ADDENDUM NO. 4

January 30, 2023

Three Rivers Community Schools – Three Rivers Middle School Additions and Renovation

This Addendum consists of Pages ADD 4-1 through ADD 4 - 3, Attached RFI Log, Substitution Request, and GMB Architecture and Engineering Addendum No. 4, dated January 26, 2023, consisting of 4 pages, Reissued Specification Sections; 08 71 00 – Door Hardware, 09 22 16 – Non-Structural Metal Framing, and 09 65 19 - Resilient Tile Flooring, New Sheet; S3.1E, and Reissued Sheets; G0.00, G1.01, G2.01, C8.01, A1.1E, A2.1E, A2.30, A5.01, A6.01, A7.03, A8.01, A8.02, M1.1D, M1.1E, M1.81, M2.1C, M2.1D, M2.1E, M3.1D, M8.01, M8.03, M8.04, M9.01, M9.02, E1.1C, E1.1D, E2.1D, E2.1E, and E7.01.

UNIT 'E' FIRST FLOOR POWER & COMMUNICATIONS PLAN
1/8" = 1'-0"

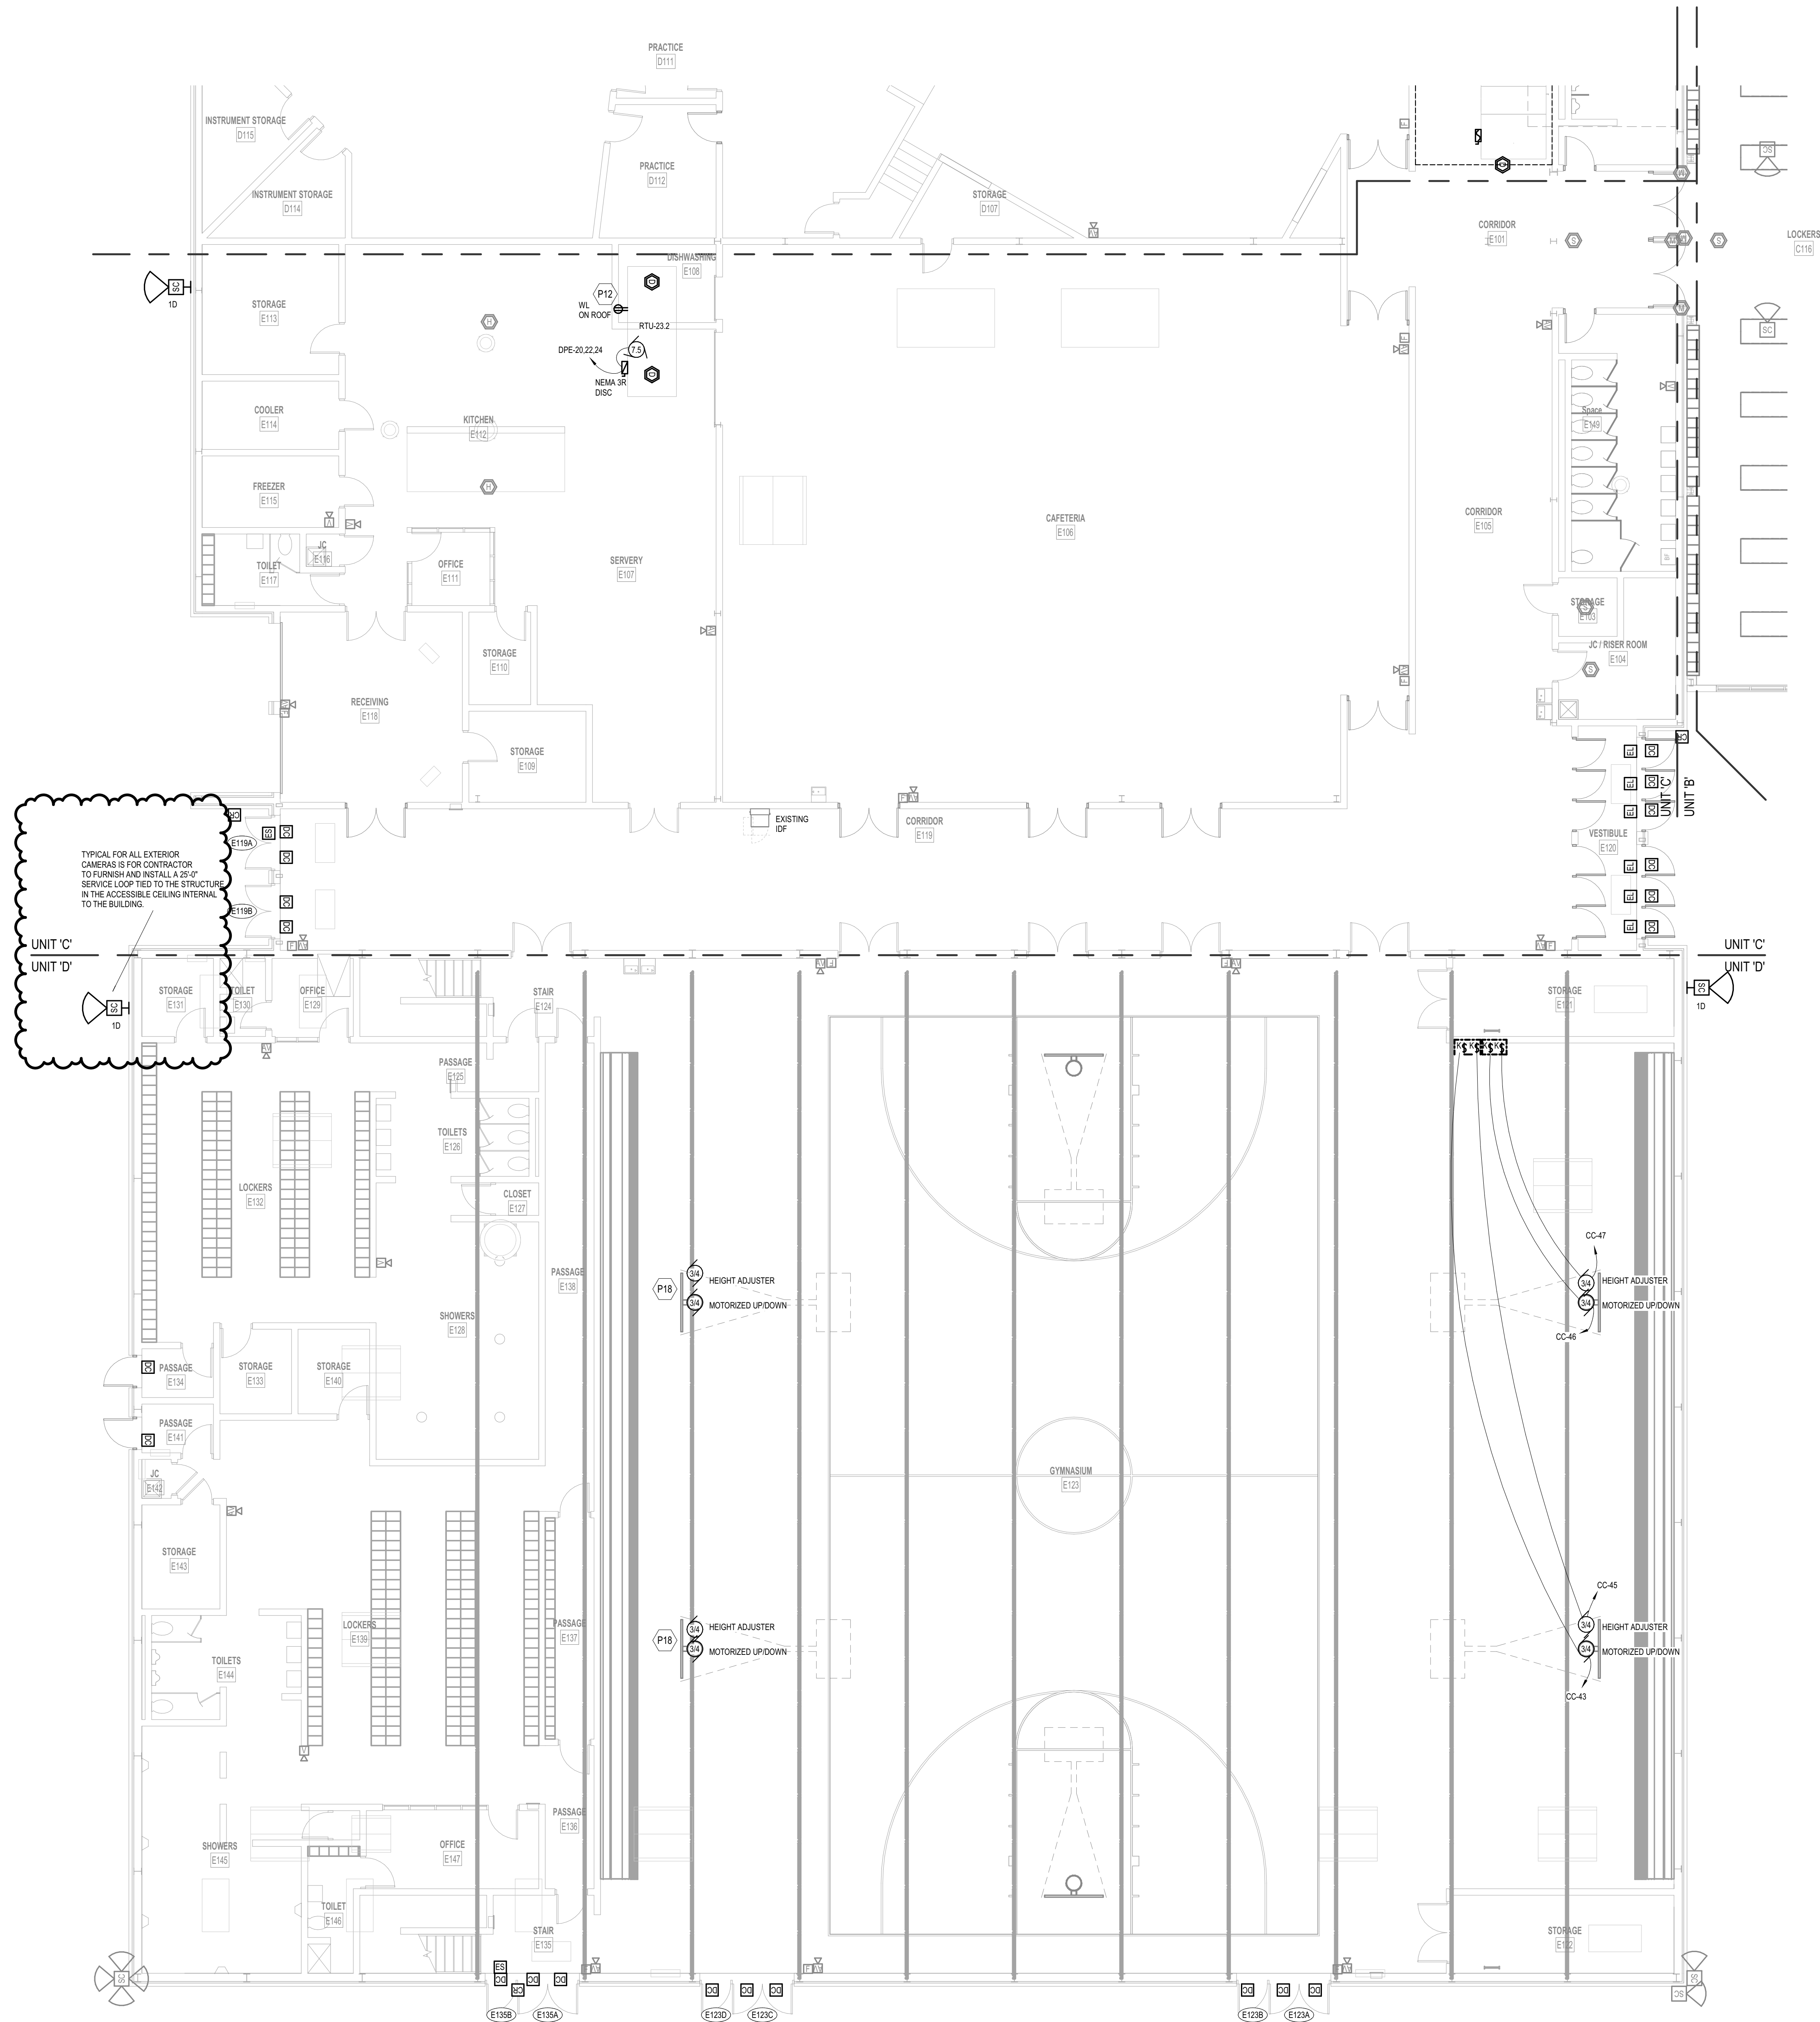
Refer to the plan for the added note for exterior cameras.
